SK#28- Rev-2
02-13-2026

PROJECT ADDRESS : 4025N. EAGLE VALLEY ROAD, HOWARD, PA 16841

DWG DESCRIPTION : STAIR ELEVATION VIEW

1 SE705 ELEVATION VIEW

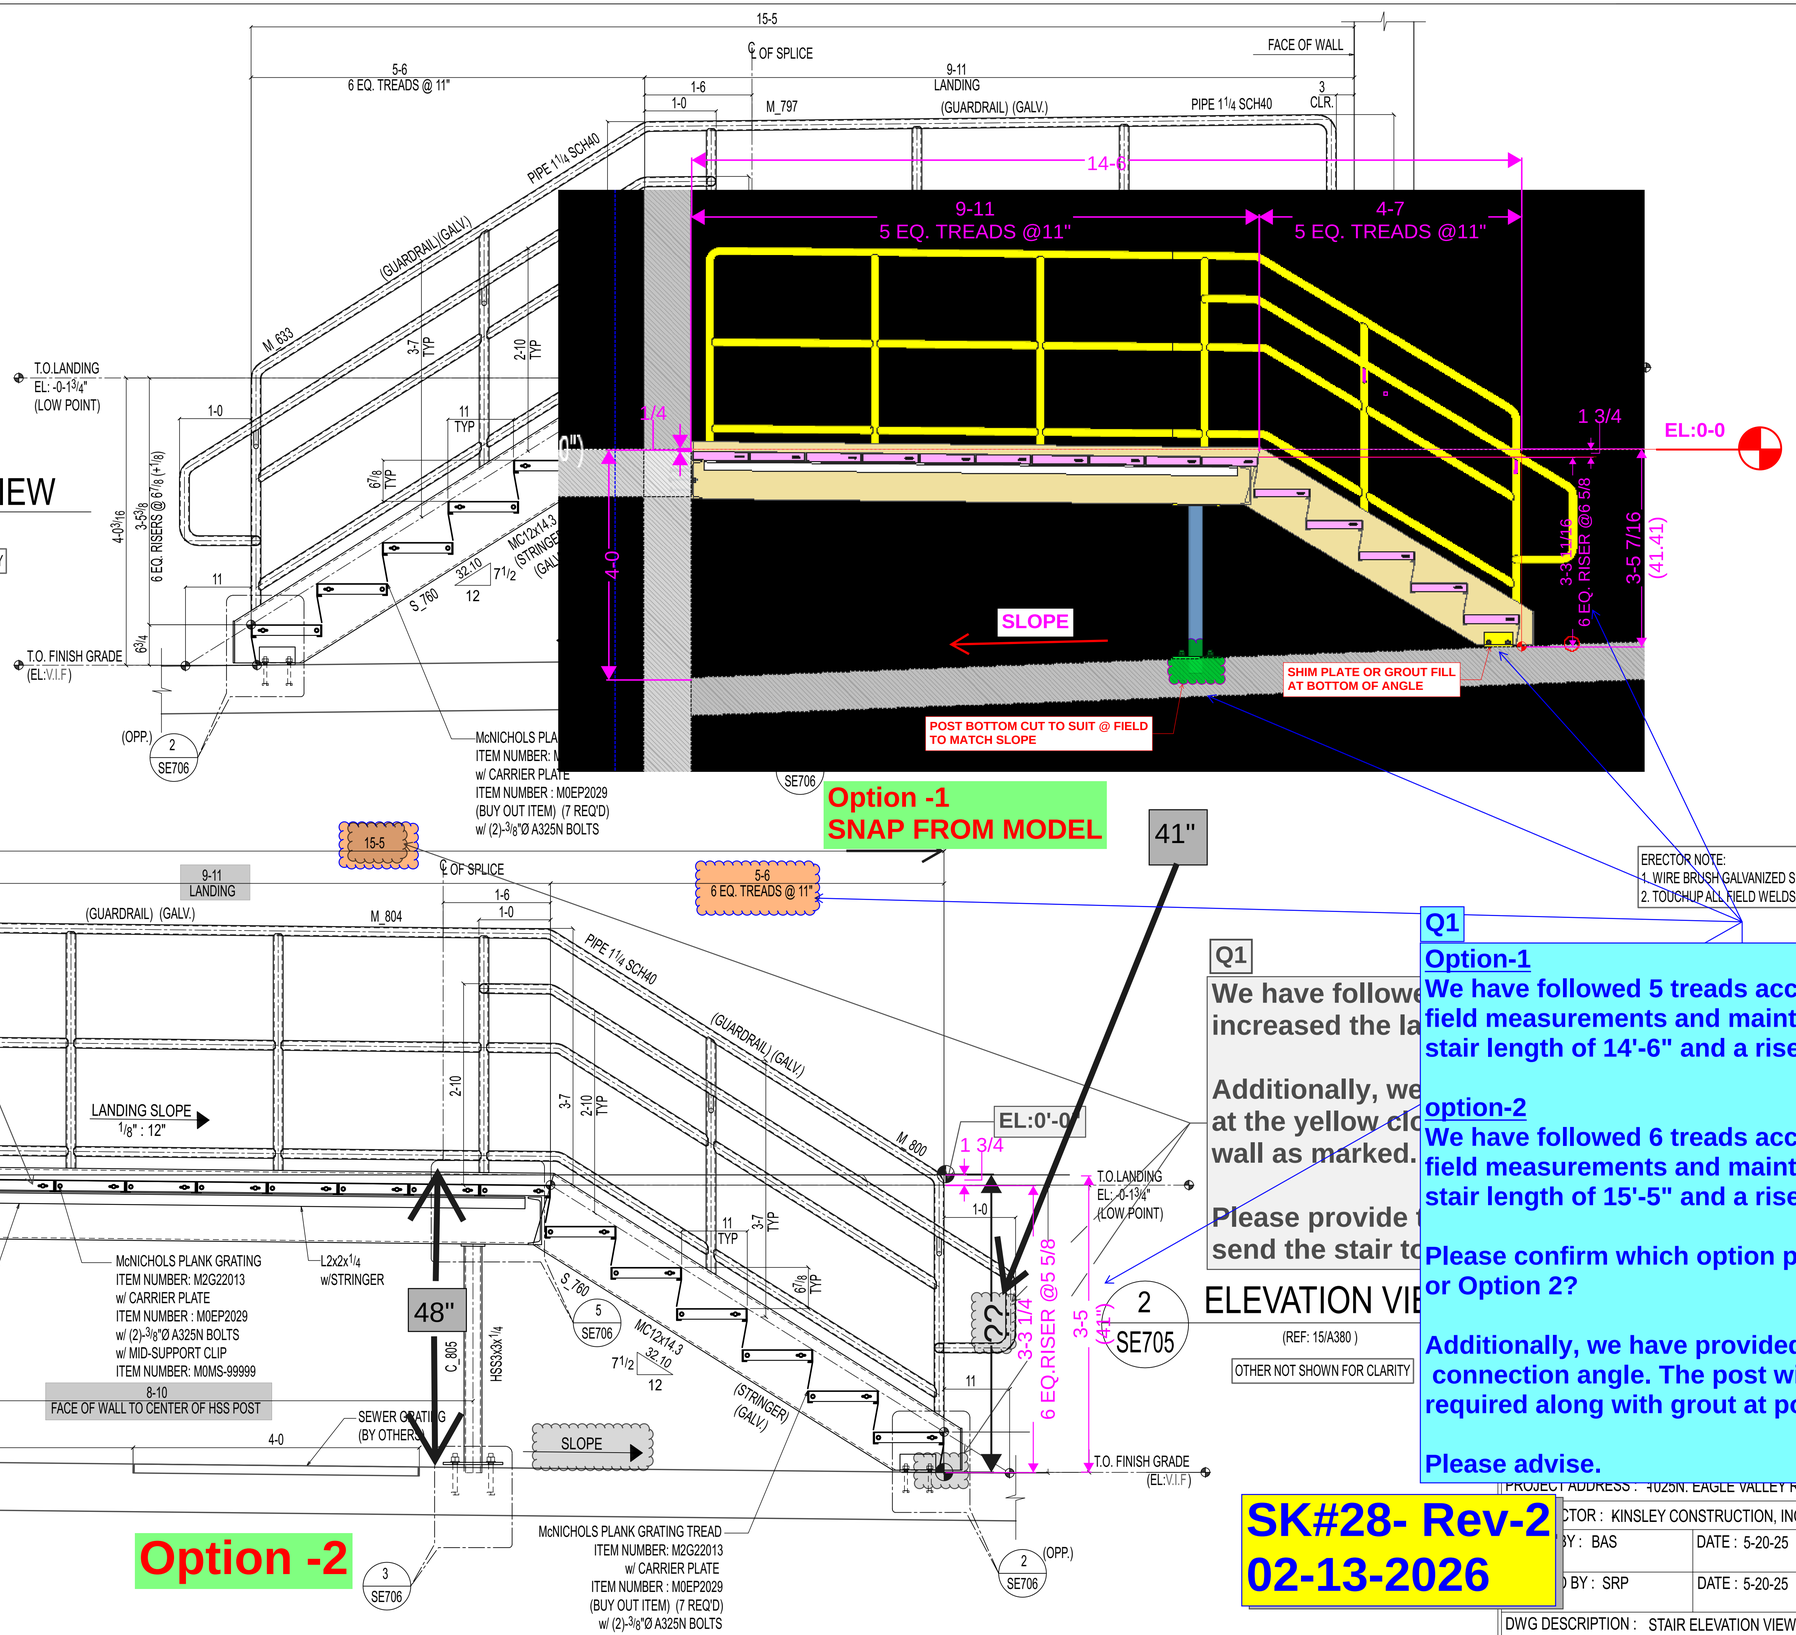
Q1

We have followe
increased the la

Additionally, we
at the yellow clo
wall as marked.

Please provide t
send the stair to

Option-1

We have followed 5 treads according to the given field measurements and maintained an overall dock stair length of 14'-6" and a riser height of 6 5/8".

option-2

We have followed 6 treads according to the given field measurements and maintained an overall dock stair length of 15'-5" and a riser height of 5 5/8".

Please confirm which option preferable? Option 1 or Option 2?

Additionally, we have provided grout at the bottom connection angle. The post will be field-cut as required along with grout at post baseplate.

Please advise.
